Location:
1863, 1891, 1895 Norton
Road

Request:
Compatibility Review for
Major Subdivision

Hudson Planning Commission	CONCEPT PLAN REVIEW
Case No. 2020-914	NOVEMBER 9, 2020

Date: October 30, 2020
To: Nick Sugar, Senior Planner, Community Development
From: Nate Wonsick, P.E., Assistant City Engineer
Re: **Norton Road Subdivision
Engineering Compatibility Review - Viewpoint #20-914**

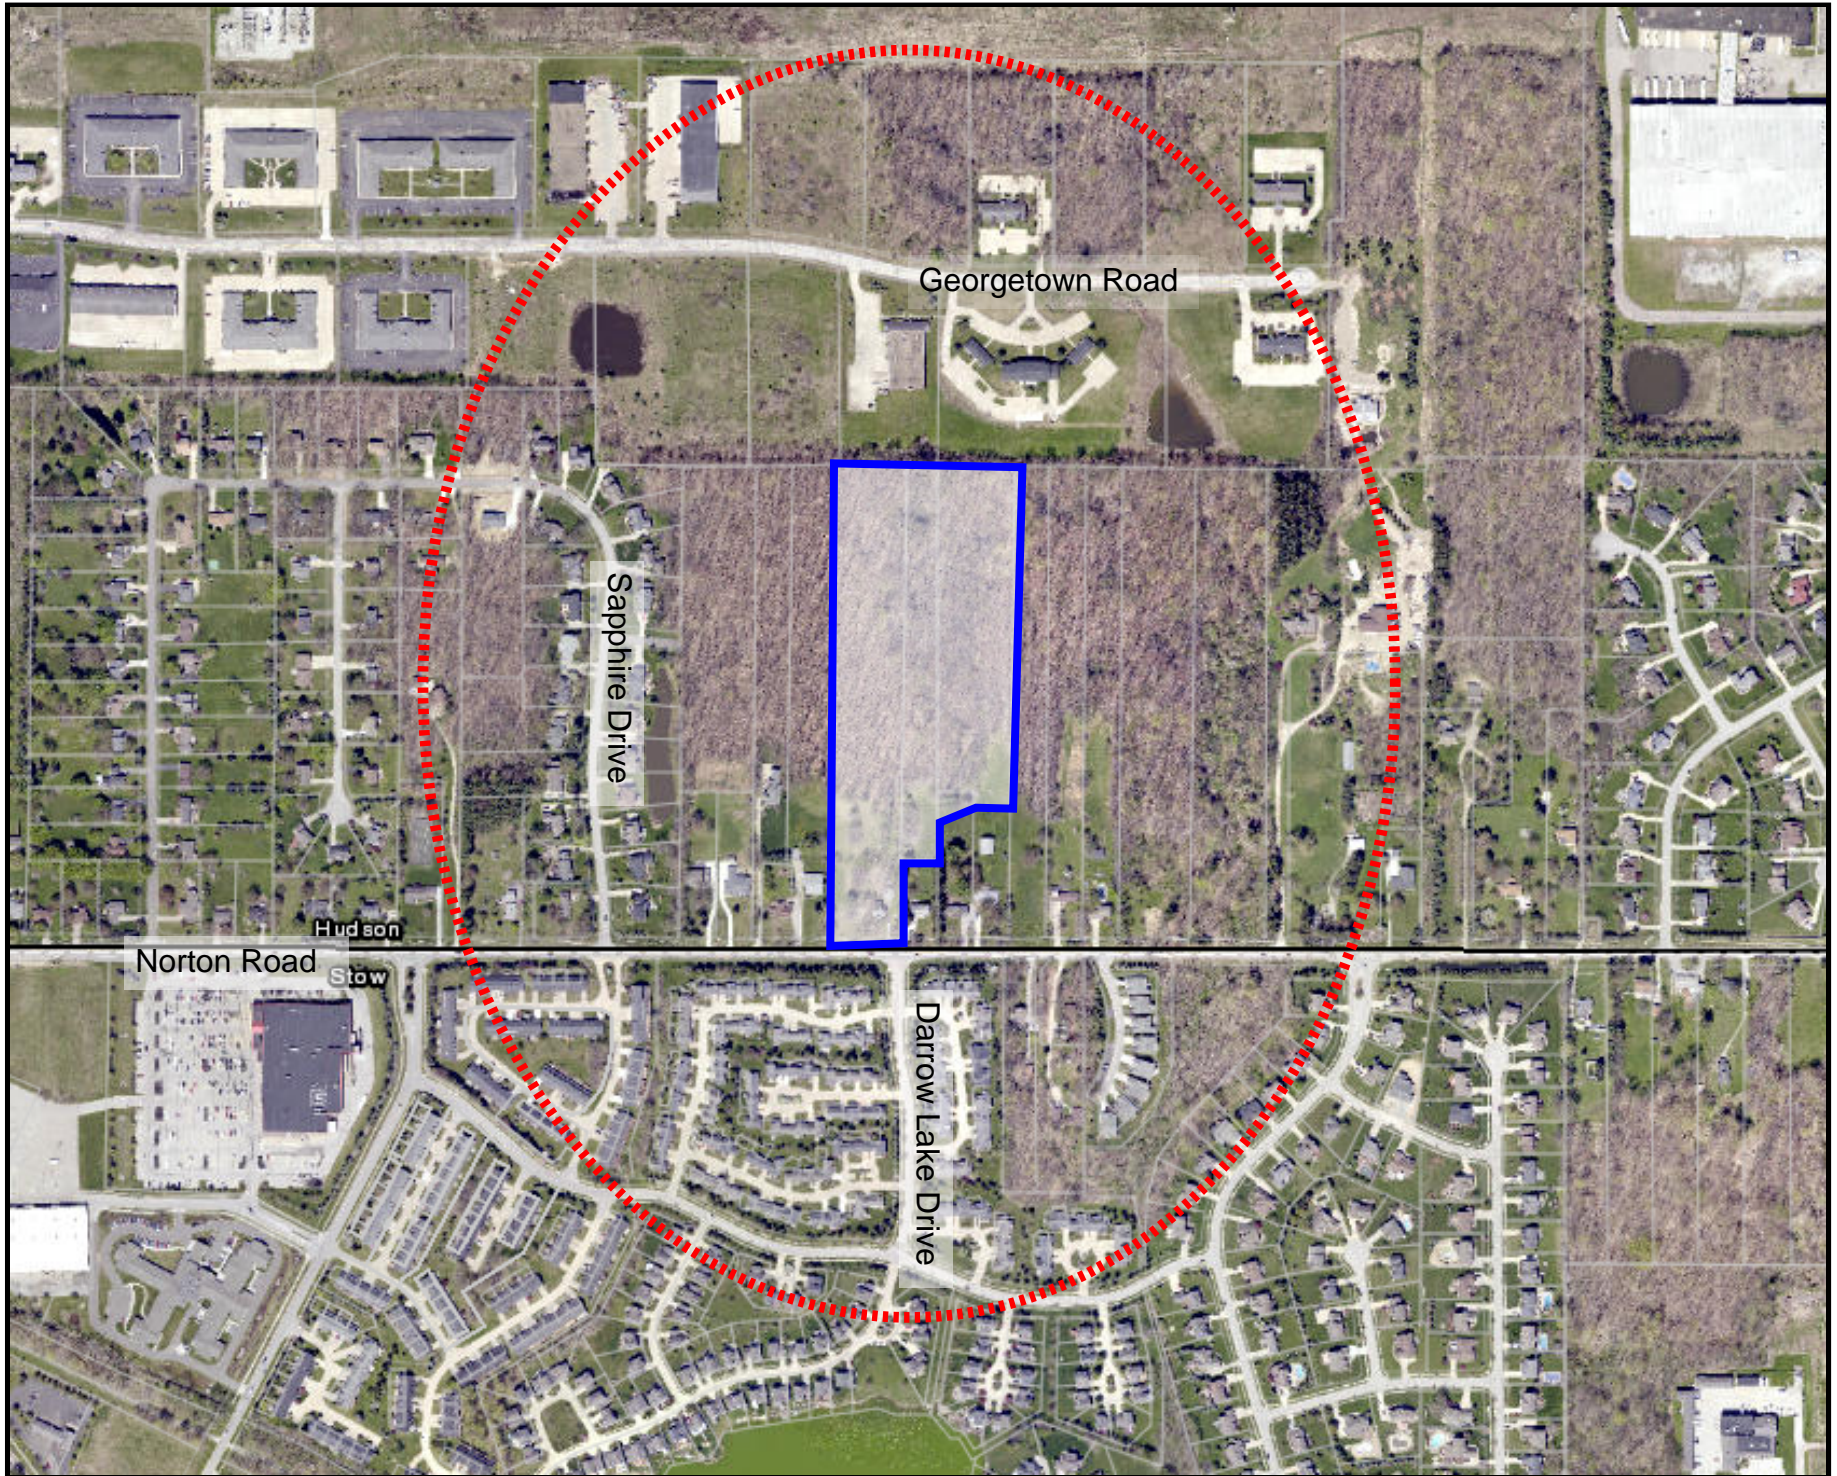
Preliminary plan depicts multiple wetland areas. A variance must be granted by the BZBA for any proposed disturbances to the jurisdictional wetlands or their applicable fifty (50) foot setback. The category of each wetland area should be noted.

Streets shall be designed to align with existing streets. The proposed street is set at an offset from Darrow Lake Drive. The City of Hudson Engineering Department has submitted a compatibility review letter and recommended either aligning with Darrow Lake Drive or maximizing the offset from Darrow Lake Drive.

The minimum lot width for properties in District 1 is one hundred (100) feet, measured along the building setback line. Lot #6 and Lot #9 are identified as deficient. The plan should be revised so all lots meet the minimum lot width requirement.

- The proposed lot sizes, ranging from 20,000 to 97,000 square feet, comply with the minimum zoning district standards.
- While adjacent single-family residential uses to the west and east do not require a bufferyard, suggest additional buffering/landscaping along the western boundaries of Lot #1, Lot #2 and Lot #3 to screen from 1849 Norton Road. Staff notes this property would be impacted by a substantial number of lots along its eastern property line.

- The stormwater detention pond located at subplot one is adjacent to the existing dwelling at 1849 Norton Road. The limits of disturbance should setback from the shared property at this location to preserve vegetation along the shared property line.

- The commercial/industrial properties to the north require a bufferyard E (major) of forty (40) feet. The proposed private open space would meet this bufferyard requirement.

- Private Open Space – 25% of the gross land area, as required by the LDC, is proposed as private open space. A ten (10') foot wide open space access easement is proposed along Lot #7. Question how the open space area will function. Suggest revising the open space and retention pond locations to maximize preservation of the large wetland area between sublots 6 and 7.
